UNITED STATES DEPARTMENT OF COMMERCE United States Patent and Trademark Office Address: COMMISSIONER FOR PATENTS P.O. Box 1450 Alexandria, Virginia 22313-1450 www.uspto.gov

| APPLICATION NO. | FILING DATE | FIRST NAMED INVENTOR | ATTORNEY DOCKET NO. | CONFIRMATION NO. |
|--|-------------|----------------------|---------------------|------------------|
| 10/692,141 | 10/23/2003 | Jin Shenghao | 15865.8a.1 | 9173 |

| • | Application No. | Applicant(s) | | | | |
|---|---|-----------------|--|--|--|--|
| Office Action Summary | Examiner | Art Unit | | | | |

DETAILED ACTION

Lin, Figure 1 (detail)

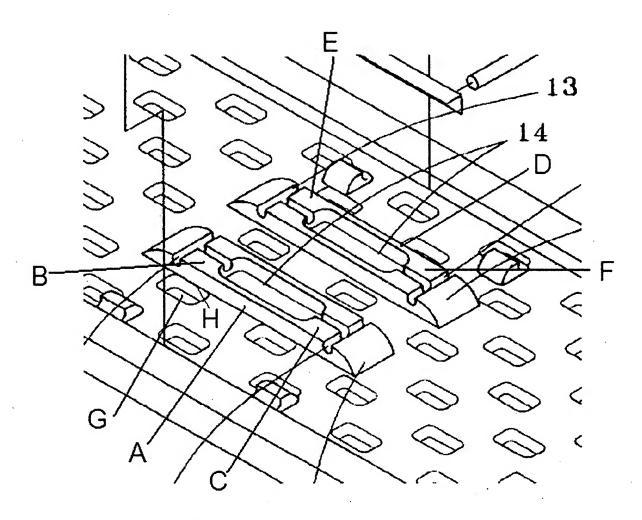
- 4. Claims 27-30 are rejected under 35 U.S.C. 102(e) as being anticipated by Lin in US Publication 2003/0233967.
 - a. Regarding Claims 27 and 28, Lin teaches a table with a blow molded tabletop (see Lin, paragraph 0017 "table plate 1 is made by a blow molding method") with a lower portion (including 11 and areas G) and first and second leg assemblies (23) movable between extended and collapsed positions, a support assembly having a first (A) and second (D) mounting structures integrally formed in the table top and including a sidewall (Best shown at A in the figure below) that forms at least a portion of the outer surface of the mounting structure, first and second support members (27), first and second crossbars (26), and a handle (H) integrally formed in the sidewall of the first mounting structure (Best seen below, the element H is integrally formed with the sidewall) and substantially disposed between the lower portion of the tabletop and a lower portion (A) of the wall), the handle being sized and configured to facilitate carrying the table (H creates a natural handle for the user).

b. Regarding Claim 29, Lin further teaches that the mounting structures have a generally C-shaped configuration and first (B and E respectively) and second (C and F respectively) ends and that the mounting structures are spaced apart from and facing each other.

- c. Regarding Claim 30, Lin further teaches that the first and second ends of the first and second mounting structures are aligned and spaced apart from each other.

- 5. Claims 32-35 are rejected under 35 U.S.C. 102(e) as being anticipated by Lin in US Publication 2003/0233967.
 - d. Regarding Claims 32 and 33, Lin teaches a table with a blow molded tabletop (see Lin, paragraph 0017 "table plate 1 is made by a blow molding method") with a lower portion (including 11 and areas G) and first and second leg assemblies (23) movable between extended and collapsed positions, a support assembly having a first (A) and second (D) mounting structures integrally formed in the table top, the first mounting structure including sidewall (best seen at portion A) extending downwardly from the lower surface of the tabletop and disposed at an angle (the fact that the sidewall is not parallel to the lower portion inherently means that it is disposed at an angle) relative to the lower portion of the tabletop, the sidewall forming a portion of the outer surface of the first mounting structure, first and second support members (27), first and second crossbars (26), and a handle (H) integrally formed in the sidewall of the first mounting structure and substantially disposed between the lower surface of the tabletop and a lower portion of the mounting structure and sized and configured to facilitate carrying the handle (H creates a natural handle for the user).

- e. Regarding Claim 34, Lin further teaches that the mounting structures have a generally C-shaped configuration and first (B and E respectively) and second

(C and F respectively) ends and that the mounting structures are spaced apart from and facing each other.

f. Regarding Claim 35, Lin further teaches that the first and second ends of the first and second mounting structures are aligned and spaced apart from each other.

- 6. Applicant's arguments filed 10/11/07 have been fully considered but they are not persuasive.
- 7. With respect to the applicant's arguments that Lin does not teach a handle formed in the sidewall or that it is sized and configured to facilitate carrying: Lin teaches that the mounting structure has a sidewall (best shown by the wall element toward which reference Character A is drawn), that the sidewall has a handle (element H is clearly a ridge in the sidewall that acts to form a handle therein) integrally formed in the sidewall, and since the entire structure is formed as a unitary piece during a blow-molding process (See paragraph 0049), the handle and sidewall are inherently integral. The handle is disposed between the lower portion of the table top (including portion 11 and all of the underside portions G) and the lower portion of the sidewall. Lin's handle is also considered to be sized and configured to facilitate carrying the table: a user's hand or fingers, inserted into the cavity surrounding H, would necessarily be able to use the ridge as a hand-hold.
